Access Compliance Report

Public Rights-of-Way

(Curb Ramps)

Intersection ID: 18538	Main Street: SENECA_PL	Cross Street: SOUTH_BV	Location: SE
ADA ID: B39B7AF61365	Ramp Type: Perp	Initial Pass/Fail: Fail	Overall Compliance: No
Severity Score: 13.75			
Codes/Mitigation Info/Possible Solution		Field Measurements/Component Compliance

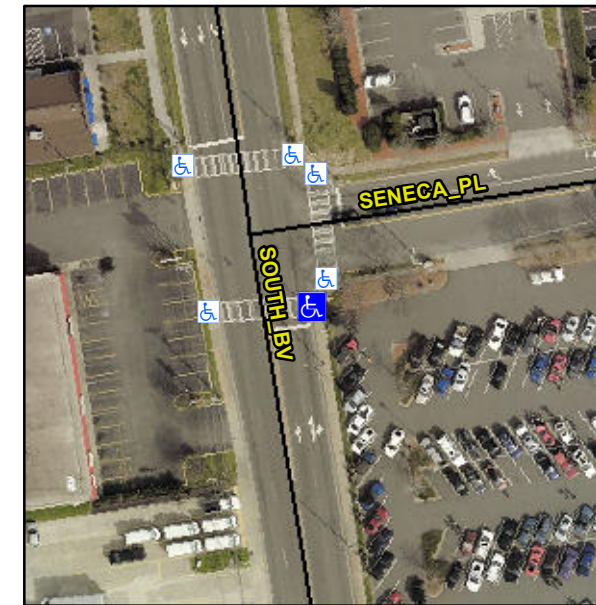
Not Found, R304.2.2, R304.5.3

Compliance	Description	Data	Compliance	Description	Data
N/A	Ramp Length (in)	68.0	No	Ramp Slope (%)	8.7
Yes	Ramp Width (in)	49.0	No	Ramp XSlope (%)	2.2
N/A	Flare Type LT	N/A	N/A	Flare Type RT	N/A
N/A	Flare Slope LT (%)	N/A	N/A	Flare Slope RT (%)	N/A
N/A	Flare Traversable LT?	N/A	N/A	Flare Traversable RT?	N/A
N/A	Landing Length (in)	N/A	N/A	DWS Provided?	N/A
N/A	Landing Width (in)	N/A	N/A	DWS Contrast?	N/A
N/A	Landing Slope (%)	N/A	N/A	DWS Length (in)	N/A
N/A	Landing X Slope (%)	N/A	N/A	DWS Full Width?	N/A
N/A	Landing Curb? (Y/N)	N/A	N/A	DWS Offset (in)	N/A
N/A	Shared Landing?	N/A			
N/A	Gutter Ponding?	N/A	N/A	Gutter Slope (%)	N/A
N/A	Gutter Lip Ht (in)	N/A	N/A	Gutter X Slope (%)	N/A
N/A	Painted X Walk1?	Yes	N/A	Painted X Walk2?	N/A
	X Walk 1 Direction	To W		X Walk 2 Direction	N/A
N/A	X Walk 1 Width (in)	107.0	N/A	X Walk 2 Width (in)	N/A
	X Walk 1 Slope (%)	5.1		X Walk 2 Slope (%)	N/A
	X Walk 1 X Slope (%)	1.0		X Walk 2 X Slope (%)	N/A

Remove & Replace Entire Ramp.
